CITY OF WEST LAKE HILLS, TEXAS
NOTICE OF ZONING & PLANNING COMMISSION (ZAPCO) REGULAR MEETING
Wednesday, April 17, 2024 at 6:30 PM

AGENDA REPORT

Zoning and Planning Commission

Zoning and Planning Commission

Proposed New Front Setback

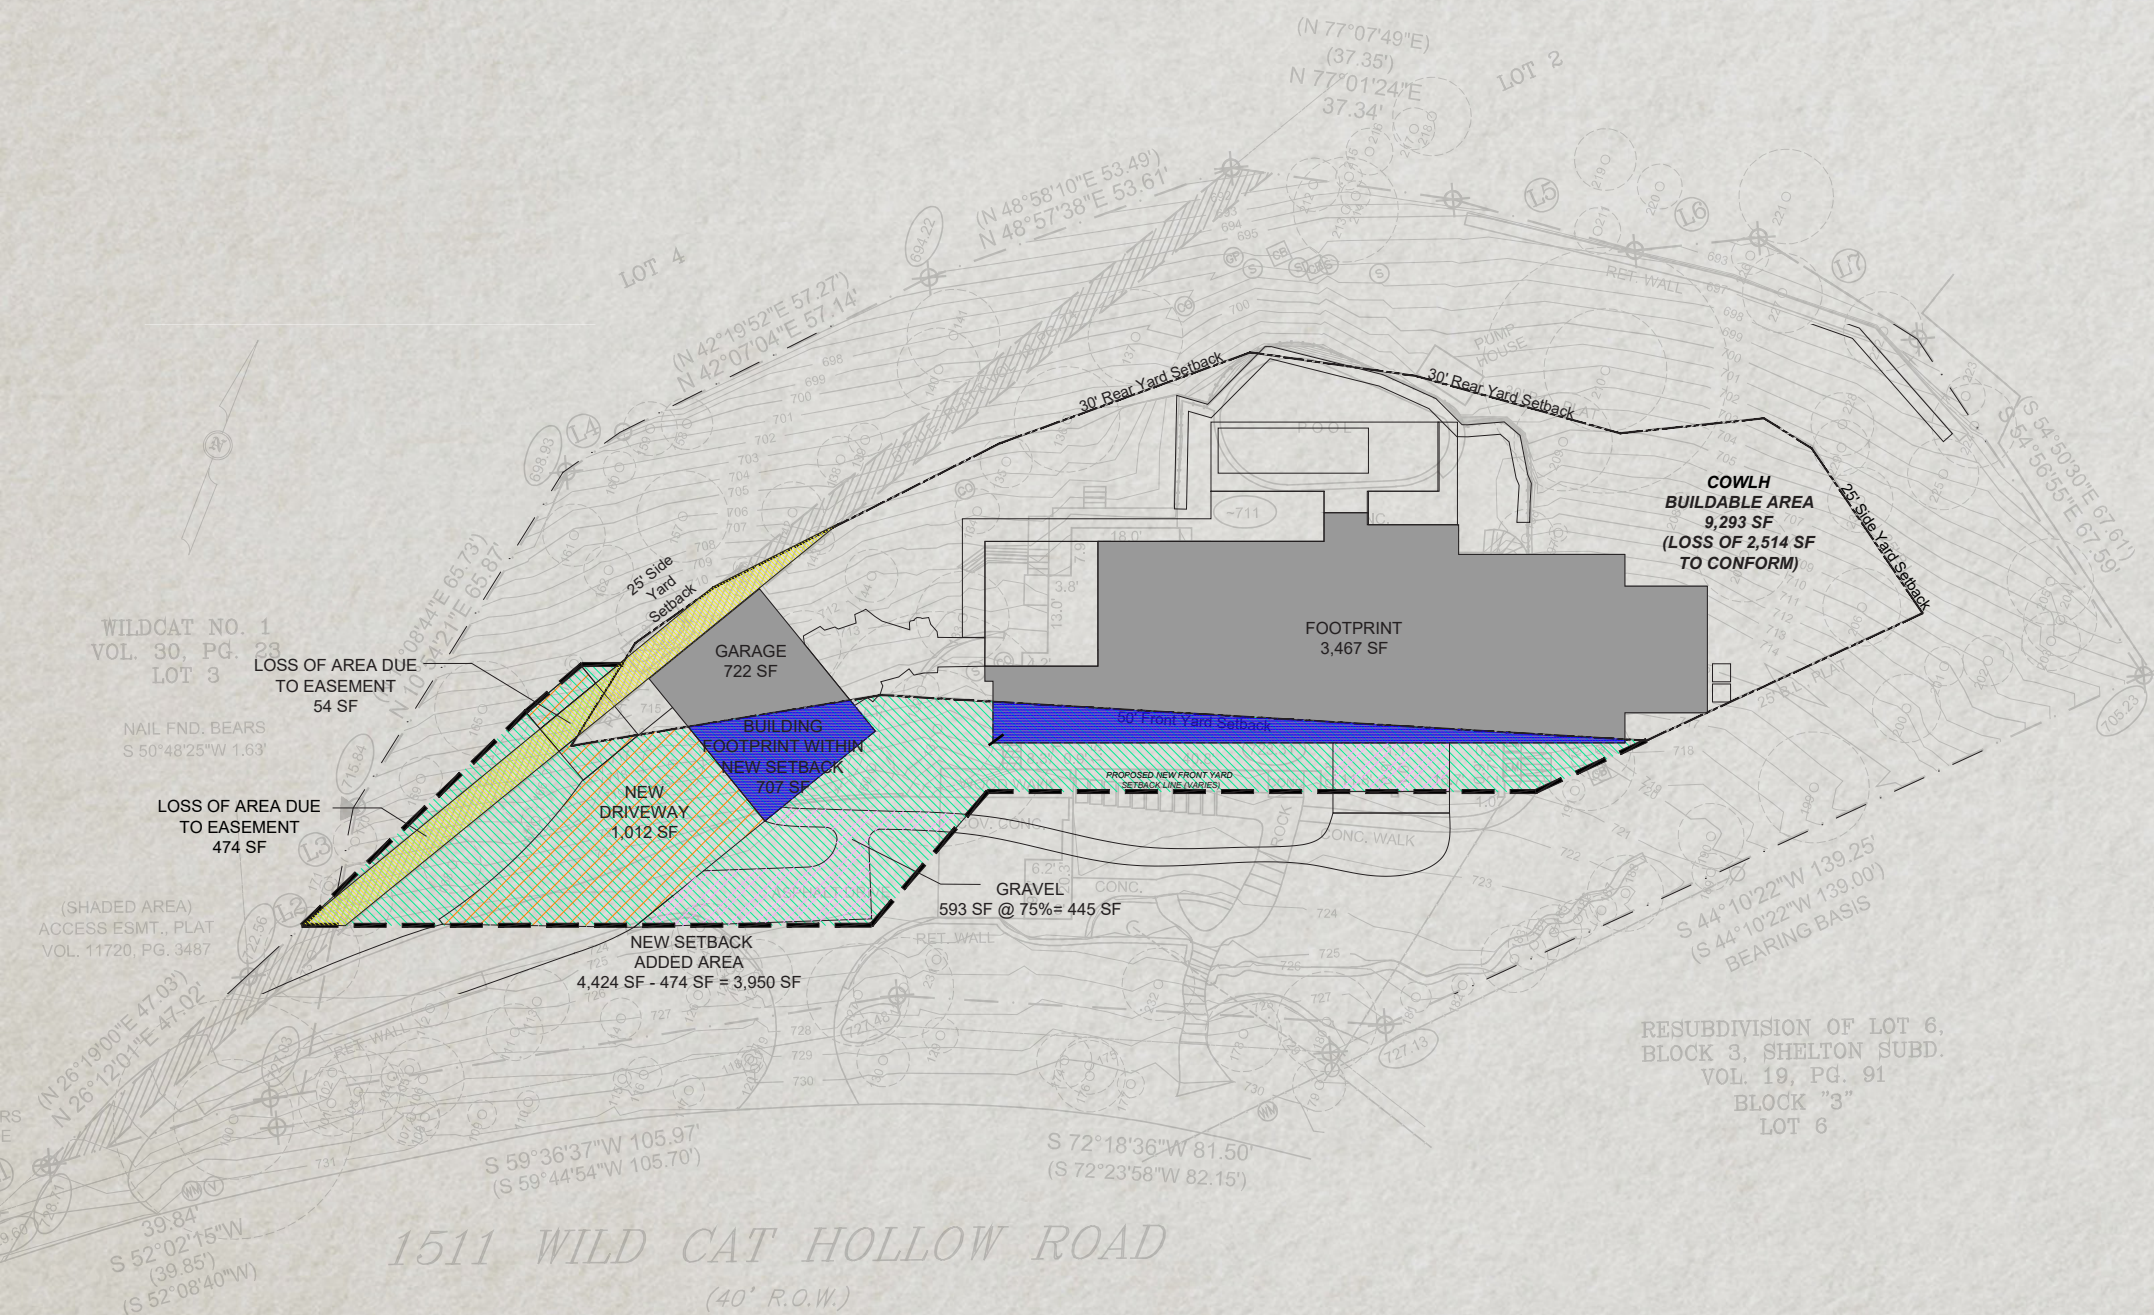
1. Front yard setback adjustments due to encroachment and existing sit slope limiting location of proposed new detached garage (see site plan).
 - a. **The proposed setback reaches the property line at one point, for no apparent reason. We recommend denying the proposed setback show on the Site Plan. However, due to the unique shape of the property, we recommend approving a smaller front setback, such as 30', which is typical in the City of West Lake Hills for small lots (<0.5 acres).**

Staff recommends approval of the variance request with conditions based on the analysis in the staff report.
Condition – the building and driveway be allowed to encroach up to 30 feet into the front setback but not as depicted in the site plan (encroachment limit is parallel to the front property line). The side setback will remain at 25 feet.

Staff recommends approval with the condition that the encroachment area be limited to 30 feet into the front setback. The site plan included in the application shows a variable setback that curves into the side setback. The limit for the encroachment should be a line that parallels the front property line until it meets the side setbacks.

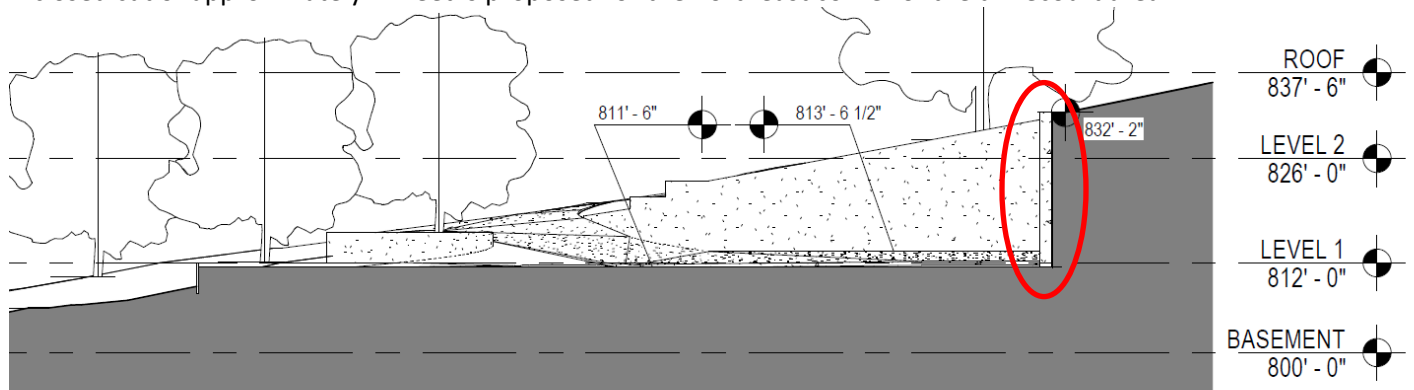
Slope	Open Cuts and Fills	Closed Cuts	Closed Fill
0 - 15%	3 feet	20 feet	6 feet
15 - 25%	1 foot	15 feet	6 feet
25% - 35%	0 feet	10 feet	6 feet
> 35%	0 feet	0 feet	0 feet

Given the slope of the property, the owner is limit to closed cuts of no more than 10 – 15 feet on the property. A closed cut of approximately 21 feet is proposed for the northeast corner of the drivecourt area.

E-W SECTION @ DRIVECOURT- 3/P005

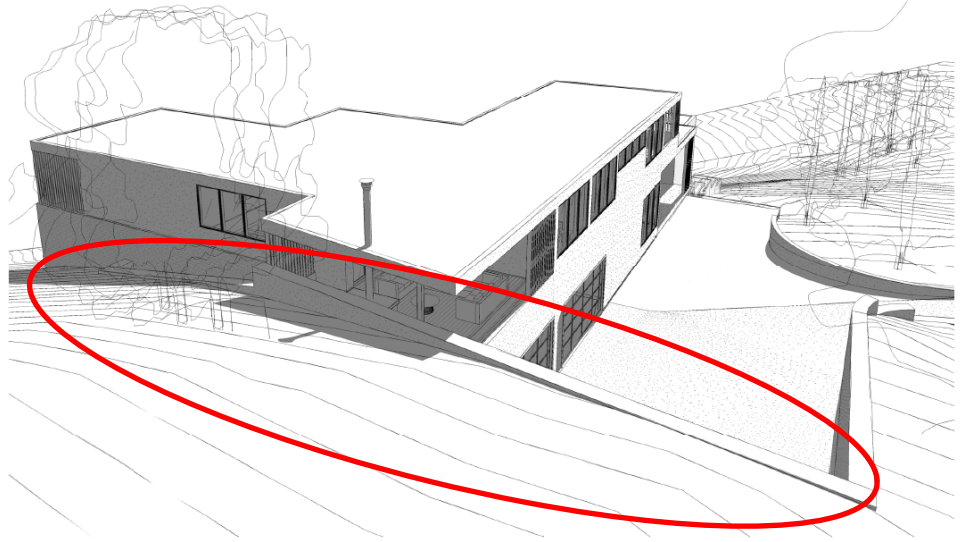
The closed cut will get smaller as it goes south, as the property is sloping down, and the house will be built more into the natural terrain.

Staff recommend denial of up to a 21-foot closed cut. More information from the applicant that no other alternative for the garage placement that may reduce the amount of cut into the hill side.

ENGINEERS PROPOSED
DRAINAGE PLAN-
V-SWALE AND ROCK
BERM TO REDIRECT
WATER FLOW AND
SPREAD IT OUT

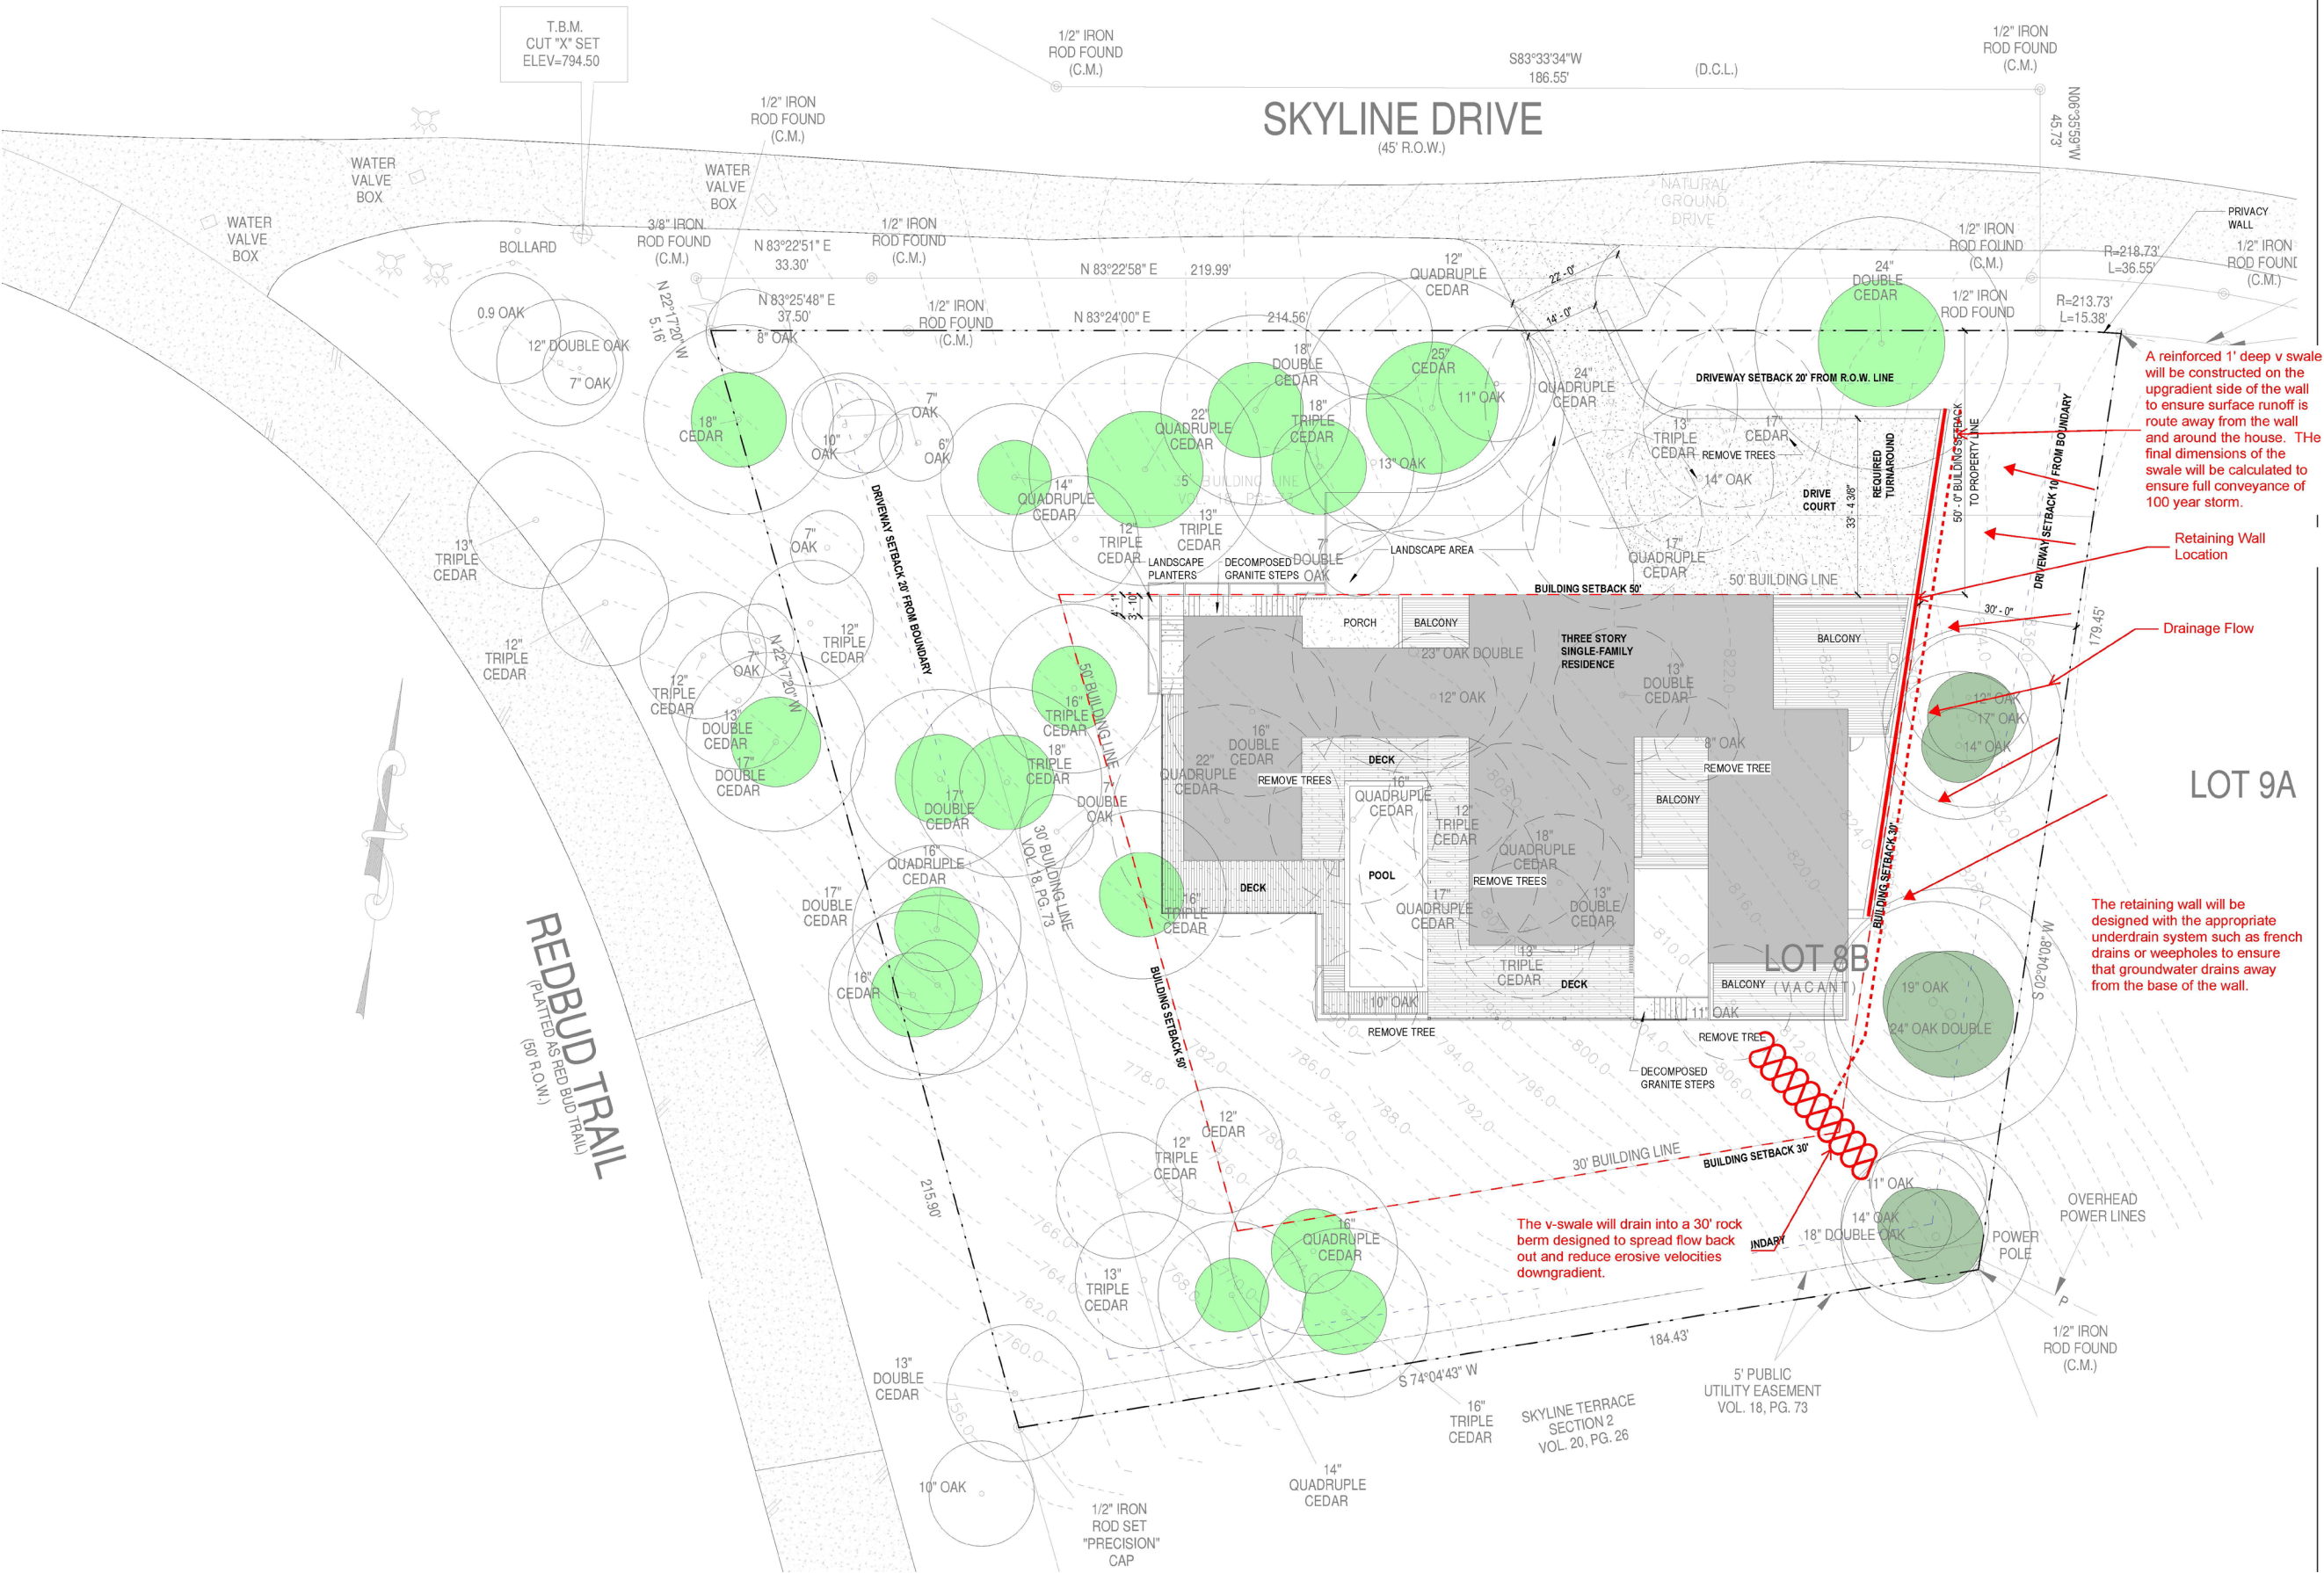
After reviewing the provided documents and the city code, the engineering team on behalf of the City of West Lake Hills recommends the following.
